ADDENDUM NO. 4

DATE: **April 5, 2022**

CONTRACT NO.: **HU-0029-B01**

PROJECT: **UNION CITY - NEW GRADE 7 THROUGH 9 SCHOOL**

A-101

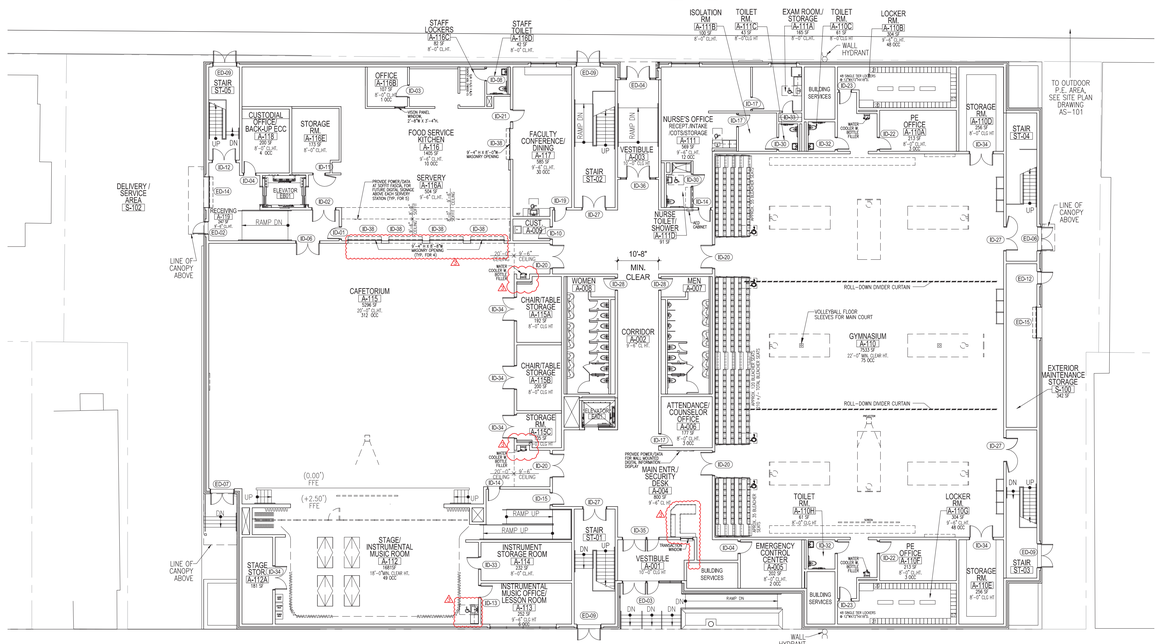
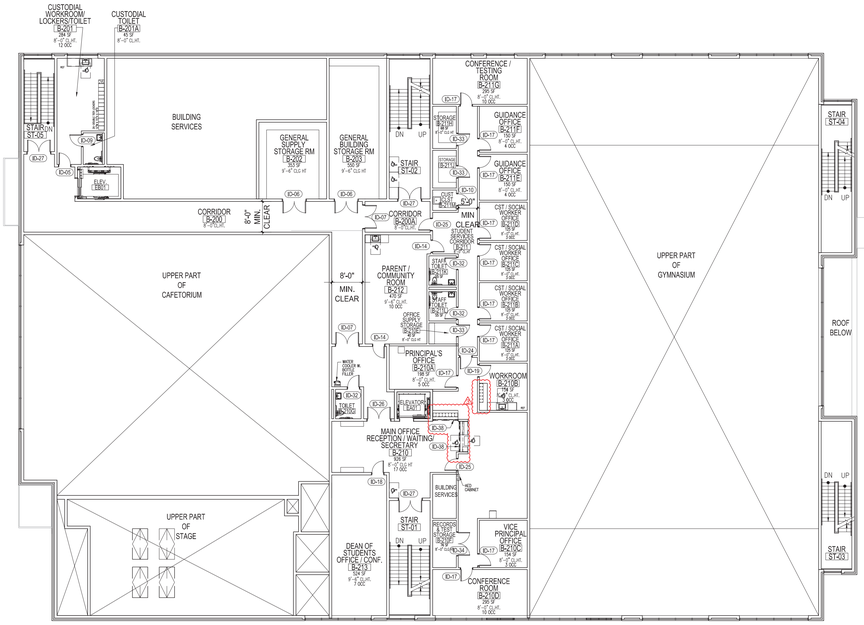
43. **Question**: Reference fit-out E-13, and drawing A-101. No exit access door has been provided from the servery where the students would be lined up. This came up by the DCA on a previous school project as the OH grille is not considered an exit access door. Please review and reconfigure area as needed to get (1) exit access door. (BQ73)

144. **Question**: Reference is made to drawings A-101, and A-201. East Elevation B on A-201 shows a total of (7) exterior display cases along the ground floor, whereas A-101 shows a total of (5). Please clarify correct quantity. (BQ176)

Response: See drawing A-101 First and Second Floor Plans and Addendum #2 section C Changes to the Educational Specifications, item a.

Response: 7 exterior display cases are required. See drawing A-201 Exterior Elevations, detail 2 East Elevation –B. See the revised drawing A-101 First Floor and Second Floor Plans.

A-102

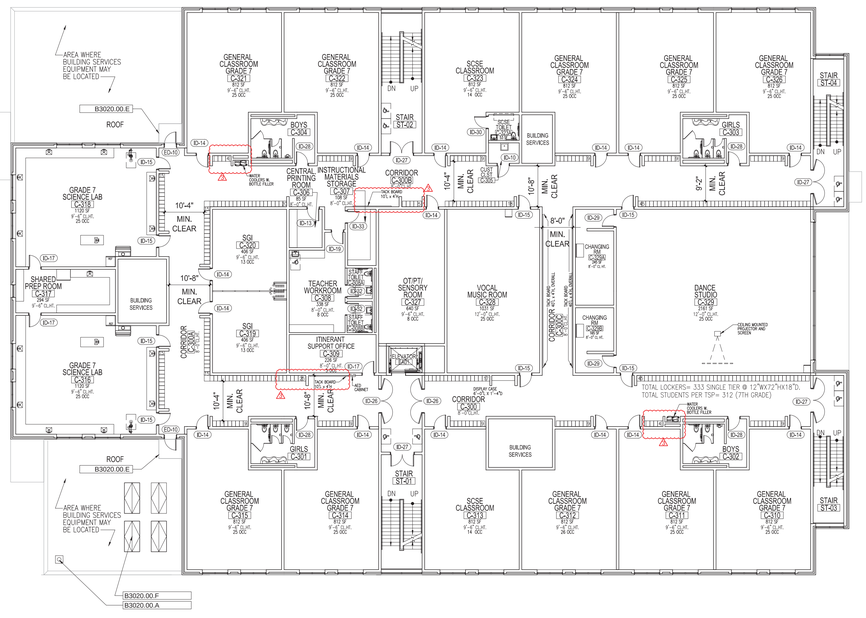
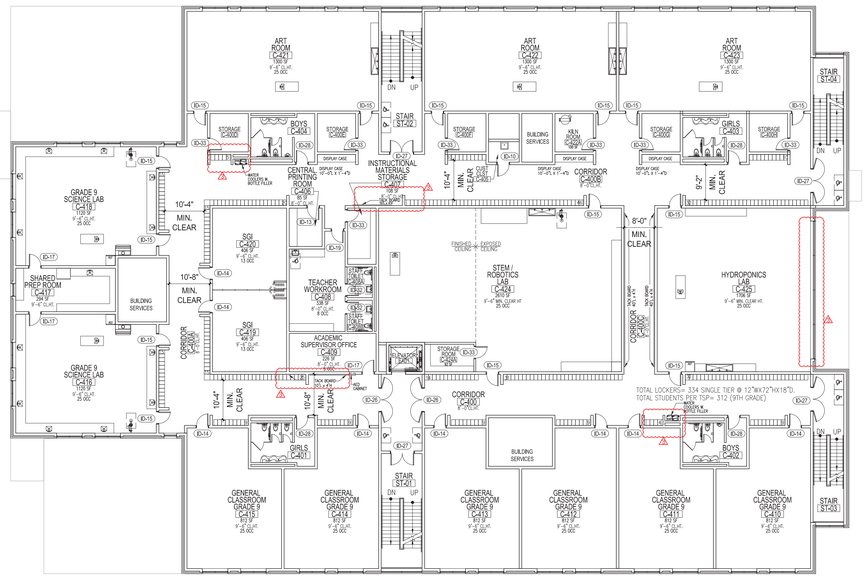
11. **Question**: Room Finish Schedule found in the Educational Specifications calls for "exposed structure" in the Hydroponics Lab, however drawing A-102 calls for a 9'-6" ceiling. Please clarify. (BQ41)

Response: Drawing A-102 requires in room C-325 Hydroponics Lab a 9'-6" clear height, not a ceiling. Exposed structure is required. Permanently installed elements shall not be below 9'-6" above the floor.

Response: The exterior window in room C-425 Hydroponics Lab is configured as 6 fixed sections and 4 operable sections. See drawing A-201 Exterior Elevations, detail 2 East Elevation – B. See the revised drawing A-102 Third Floor and Fourth Floor Plans, attached.

1 SOUTH ELEVATION AT 36th STREET - A

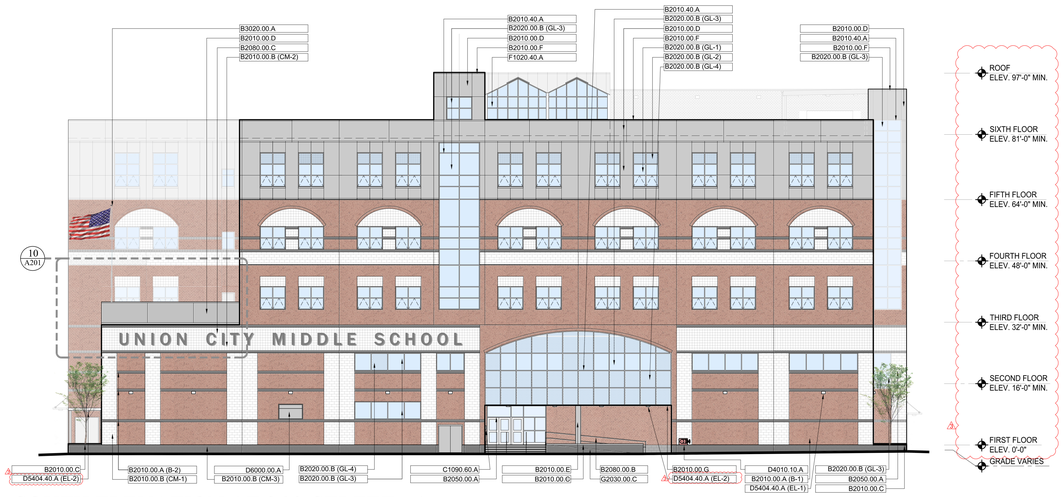
30. **Question**: Drawing A-201 Exterior Elevations, graphically depicts exterior lettering on the South Elevation with wording "Union City Middle School", or (21) Letters. Specification Section B2080.00, Section II.D.3.d states to provide up to a fifty character allowance for each sign location. Please confirm if if we are to include an additional allowance of (29) illuminated letters at this location. (BQ60)

Response: Confirmed. The building identification signage is limited to the location illustrated in sheet A-201 Exterior Elevations, Detail 1, South Elevation at 36th Street – A.

A-301

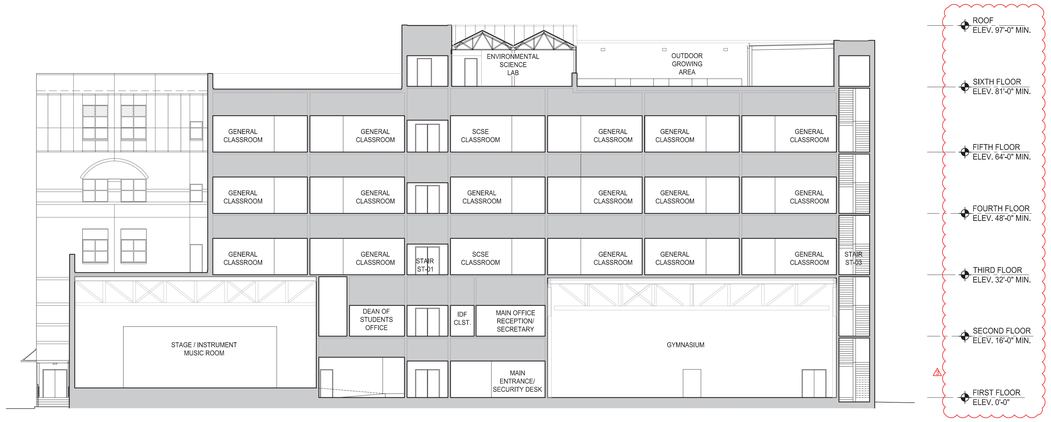
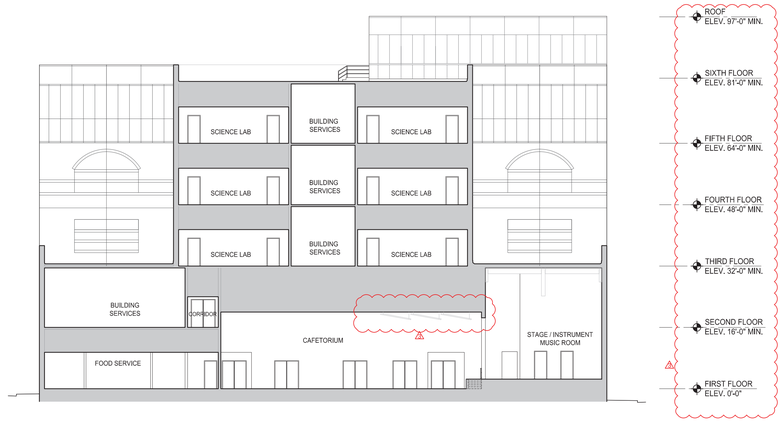
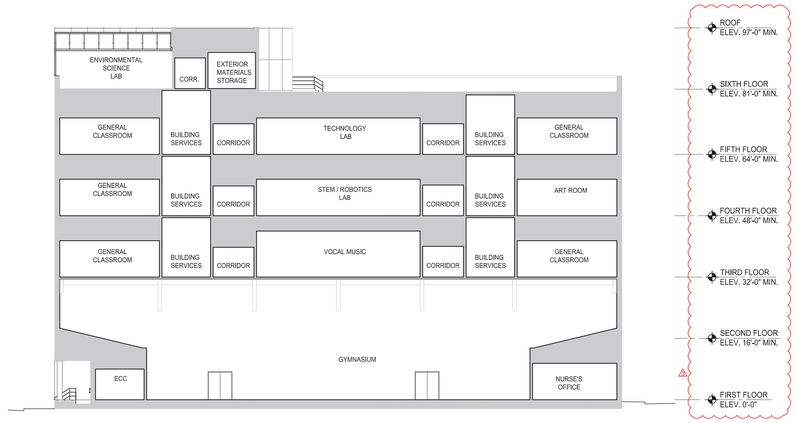
90. **Question**: Ed Spec sheet C-23, and drawing A-301 call for and show the Proscenium wall as being 18 feet high. The Stage is set at 2'-6" above the floor which puts the top of the proscenium wall at 20'-6", however drawing A-101 notes the Cafetorium to have a ceiling height of 20'-0".

Response: The ceiling mounted acoustical reflective panels shall be mounted with their low point 18'-0" above the floor of room A-115 Cafetorium. See the revised drawing A-301 Building Sections, attached. No basis of design will be provided for the ceiling mounted acoustical reflective panels. The D-BIP establishes the salient physical, functional, and performance requirements. The D-B is free to select any product that meets or exceeds these requirements.

A FOOD SERVICE PLAN
SCALE : 1/4" = 1'-0"

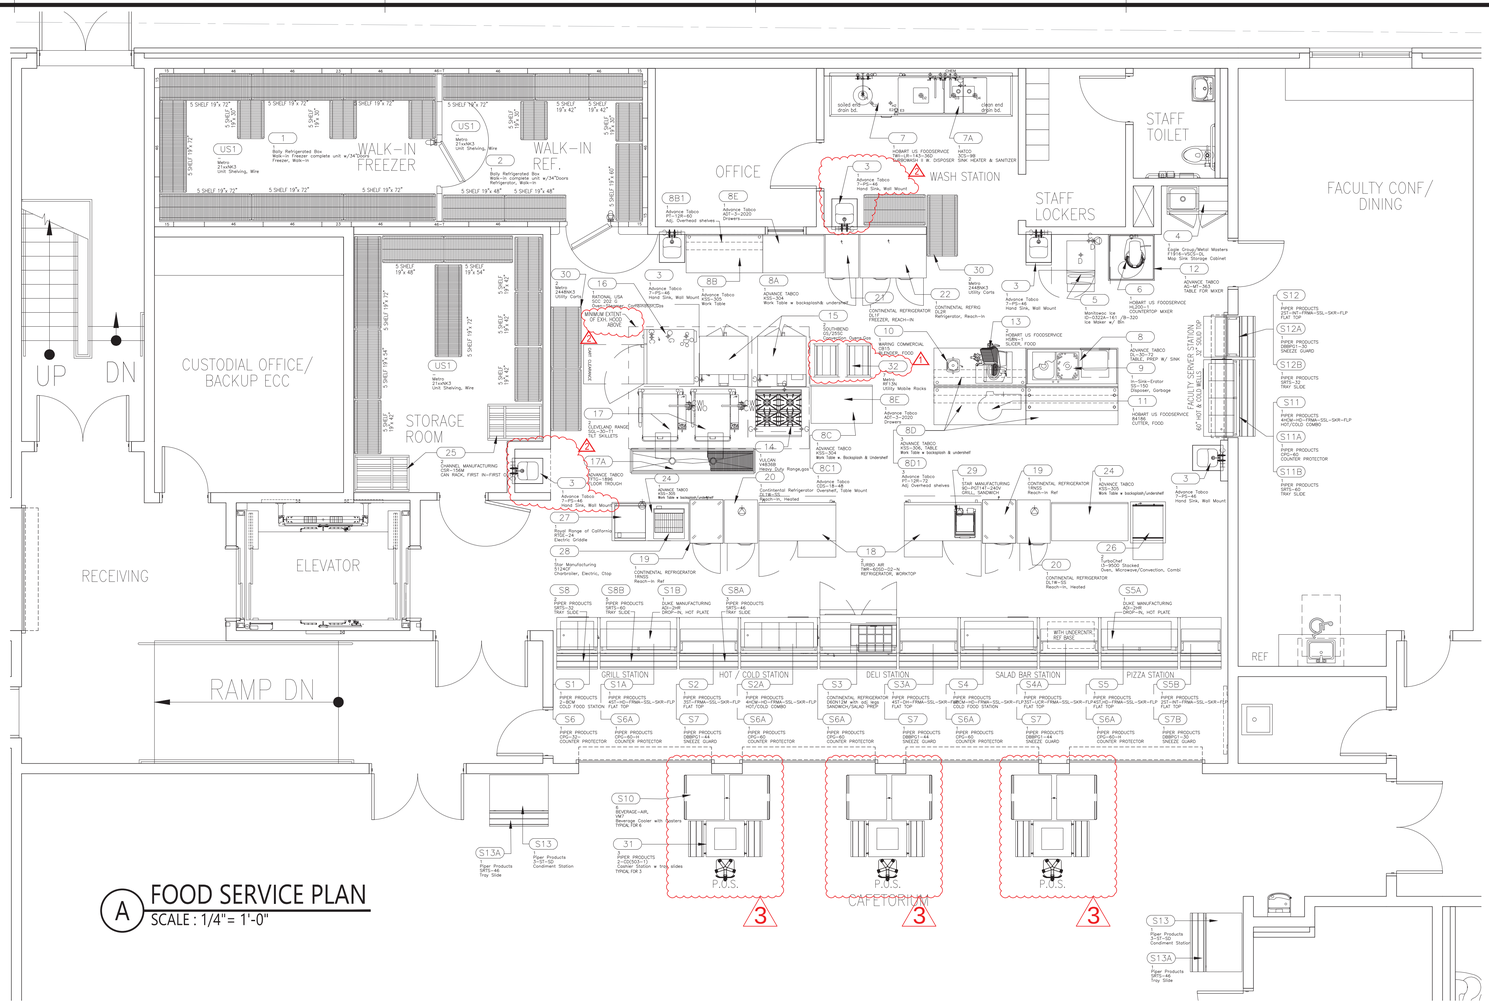
41. **Question**: Reference fit-out E-11a1 (Cafetorium), and drawing A-801. Confirm if (P/D) for the cashier stations, and (P) for the 3 sets of S-10 beverage coolers should be via a floor box. (BQ71)

Response: Not confirmed, power and data for the point of sale systems and power for the beverage cooler shall be located in the wall between the interior coiling doors. The wall area has been increased to accommodate these services. See the revised drawings A-101 First and Second Floor Plans, A-801 Food Service Plan and Equipment Schedule, and others.

AF-101

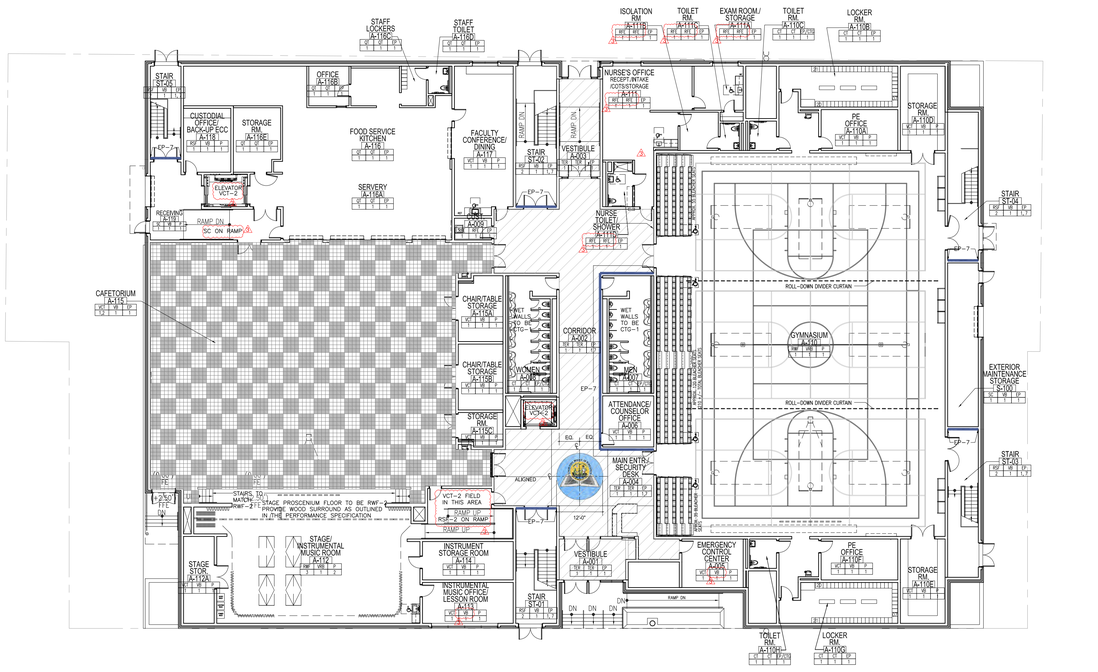
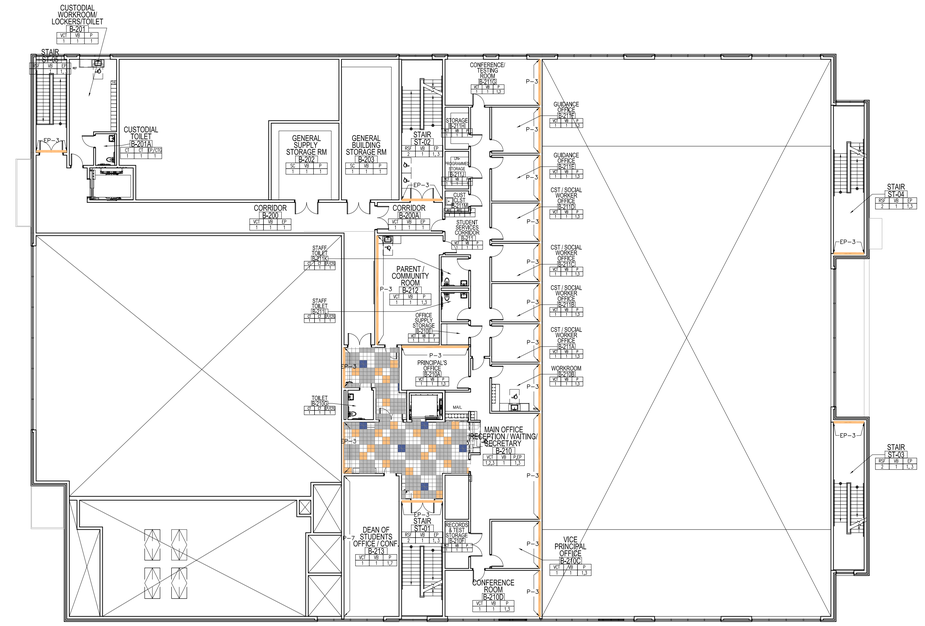
140. **Question**: Reference is made to drawing AF-101. Please provide the floor finish at the 'ramp' for the Kitchen Receiving area, including the floor finish at the 'ramp' accessing the Stage, including the floor finish at the bottom of the Stage ramp that leads in to the lobby / Cafetorium. (BQ172)

Response: The floor finish for the ramp in room A-119 Receiving shall be SC-1 Sealed Concrete. The D-B shall provide enhanced slip resistance where required by code. The floor finishes for the ramp connecting rooms A-112 Stage / Instrumental Music Room shall be VCT-2 Field, and RSF-2 on ramp. See the revised drawing AF-101 First Floor and Second Floor Finish Plans.

AF-102

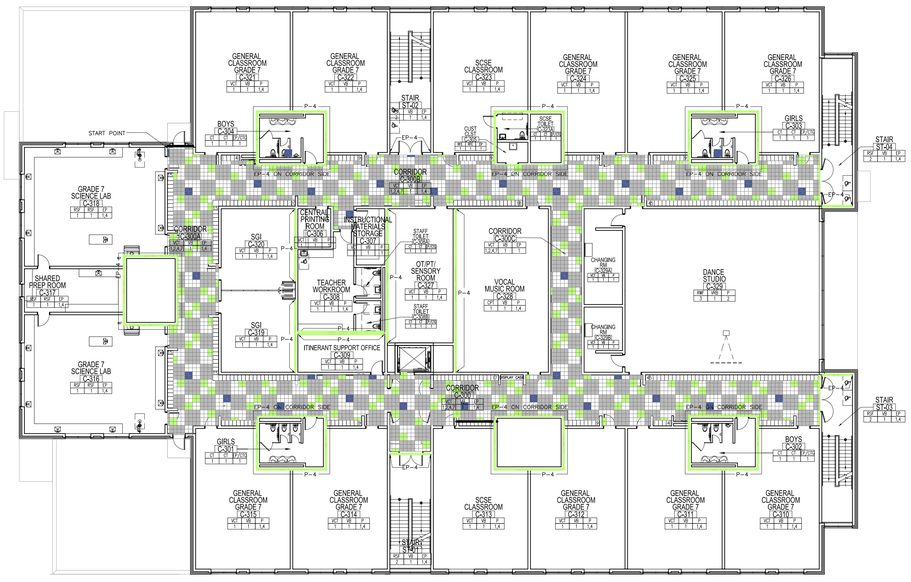
100. **Question**: Finish Style and Color Requirements (Spec Section: C2000.00 Interior Finishes / Dwg #AF-101, 102, & 103) 1. What are the Style and Color Requirements for base type RB-1 shown in Rooms A-005, A-112A, and C-400C? 2. What are the Style and Color Requirements for the Resilient Flooring type RES-1 shown in Rooms A-111, A-111A, A-111B, A-111C, and A-111D? (BQ131)

Response: 1. The base finish in rooms A-005 Emergency Control Center, A-112A Stage Storage, and C-400C Corridor shall be VB-1. See the revised drawings AF-101 First Floor and Second Floor Interior Finish Plans and AF-102 Third Floor and Forth Floor Interior Finish Plans. 2. Floor finish RES-1 shall be RFE-1. See the revised performance specification section C2000.00-1 Interior Finishes and drawing AF-101 First Floor and Second Floor Interior Finish Plans, both attached.

DRAWING # (A1-101) E-29

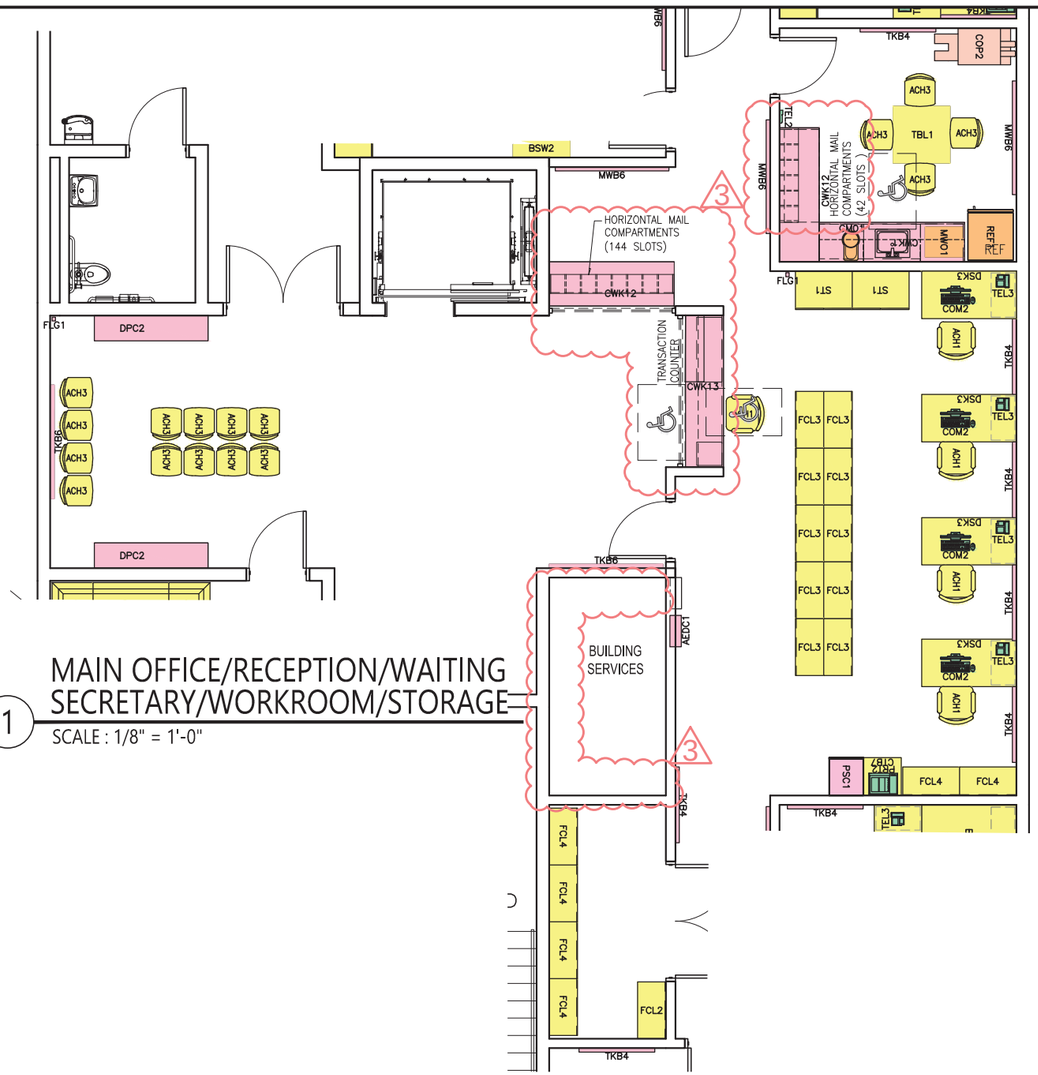
97. **Question**: Reference fit-out E-29. The plan shows a "pair of outswinging" doors from the reception opening into the fire rated elevator lobby (due to the high rise). Drawing A-101 calls for ID-38 doors which look to be overhead door types. Please note if the outswinging doors are to be eliminated, these overhead doors would need to be fire shutters to the floor. (BQ128)

Response: The configuration illustrated in drawing A-101 First Floor and Second Floor Plans is correct. No adjustment of the furniture is necessary. The Bridging Design Drawings take precedence over the Room Layout and Fit-out Lists. See the revised D-B Agreement, Section 25.3.
